**PLANNING DIVISION REPORT**  
**DEPARTMENT OF PLANNING AND COMMUNITY**  
**AND ECONOMIC DEVELOPMENT**  
**October 6, 2008**

**RE: LD. # 12153, Conditional Use Application – 610 John Nolen Drive**

DATE: September 15, 2008  
TO: Plan Commission  
FROM: Larry D. Nelson, P.E., City Engineer  
SUBJECT: 610 John Nolen Drive Conditional Use

SHEET  
A300

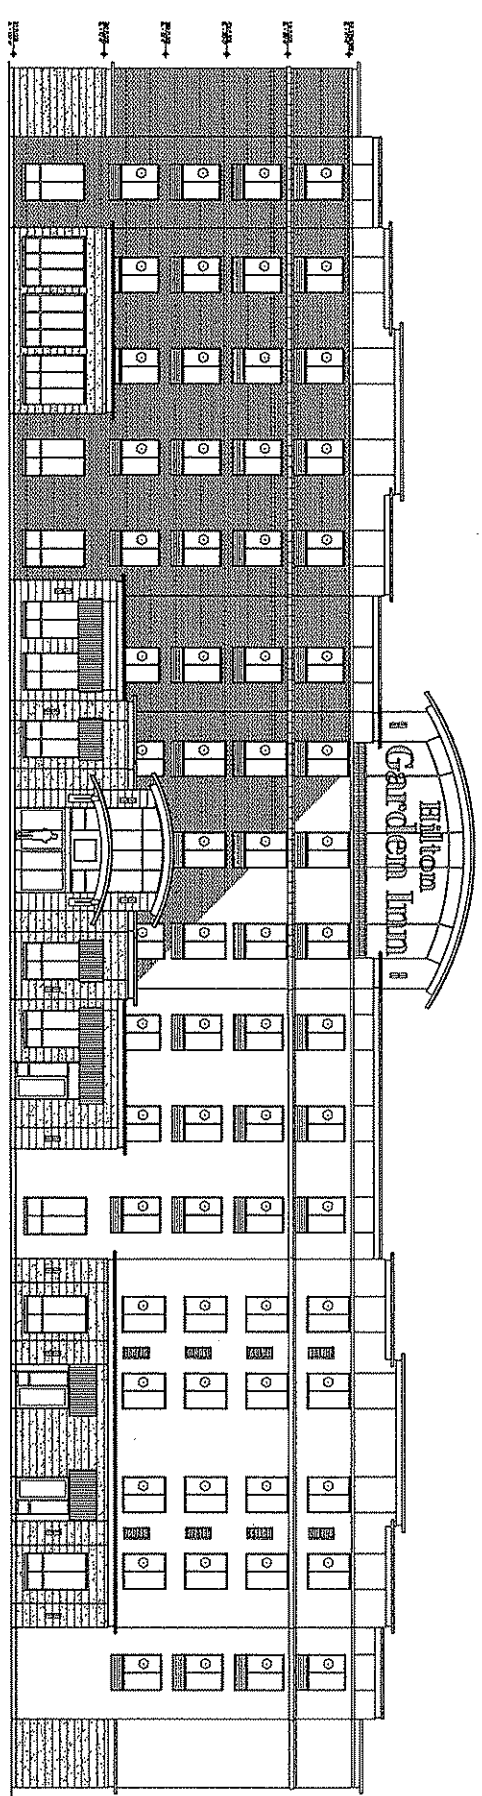
The Commission noted that the elevations showing the signs on the sides of the building had not been revised to show the belt course moved up one story to match the front elevation. The Commission discussed whether the signage on the side elevations should be centered, or offset closer to the street.

- Good.
- Side signs oversized for space.
- Signage at end of building needs better composition.
- Minor, but welcome, improvements.
